Northminster Multi-Storey Car Park

Structural Review Report

Structural Review Peterborough City Council

August 2019

Figure 1: Spalled concrete protection around column exposing corroded steel collar.

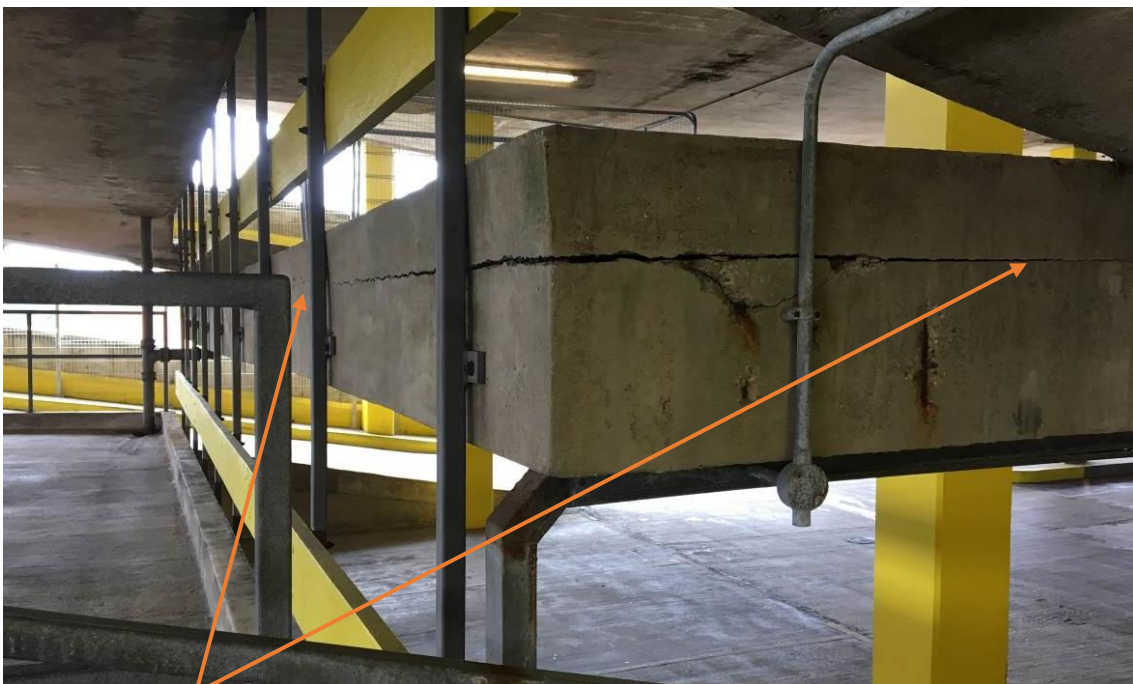
This corrosion is clearly affecting safety critical steel elements including the shear blocks and the highly stressed steel reinforcement adjacent to the connection between the slabs and columns. This corrosion has also led to the delamination of concrete directly beneath. See **figure 1**. It is worth noting that these areas are not easily inspected without carrying out localised concrete breakouts or using specialist surveying equipment. Therefore, the current condition, and potential deterioration to all the columns is currently unquantified.

Figure 3: Fresh cracking through repair material around base of column, crack <2mm wide.

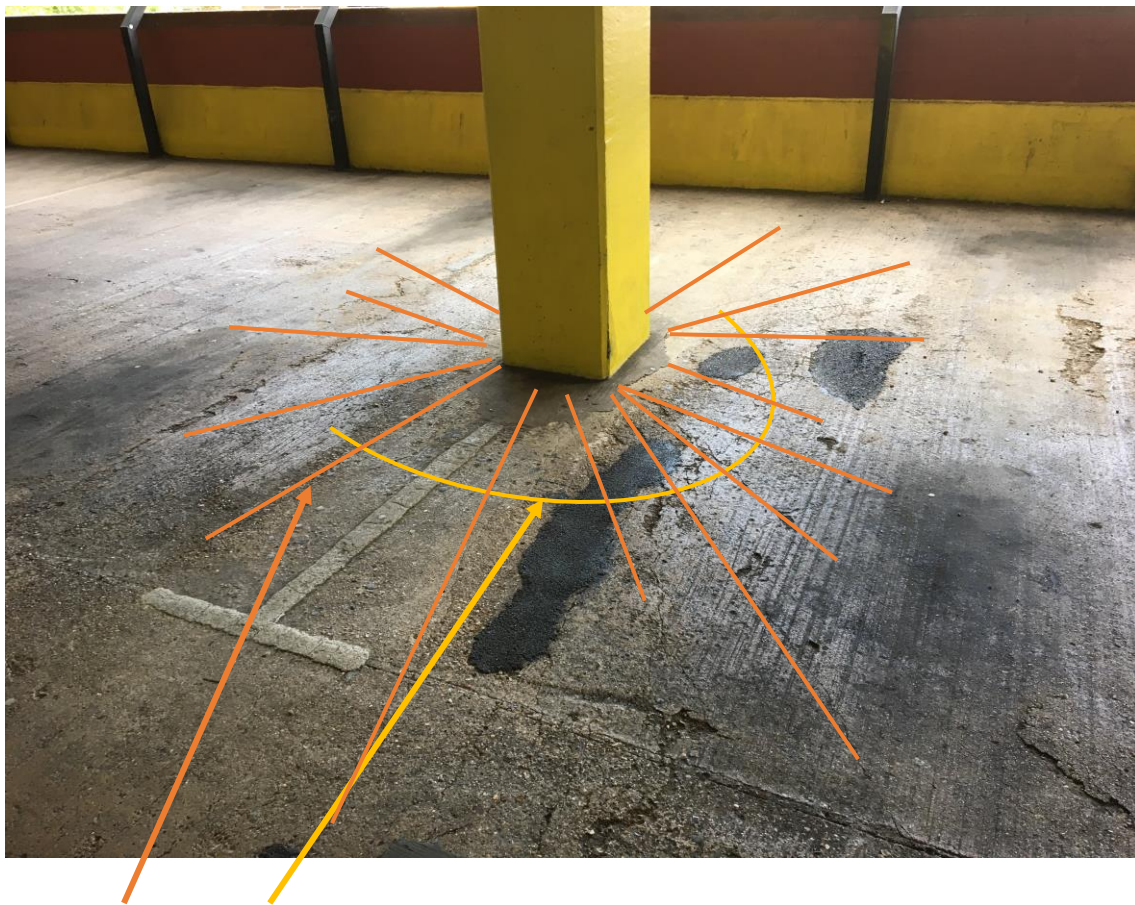
- There is radial cracking emanating from all columns and circumference cracking around some columns which appears to reflect patterns similar to that of a punching shear failure. These cracks appears to be a longstanding defects, however there is evidence of more recent deterioration with the appearance of fresh cracking through recent concrete repairs. See **figure 3**.
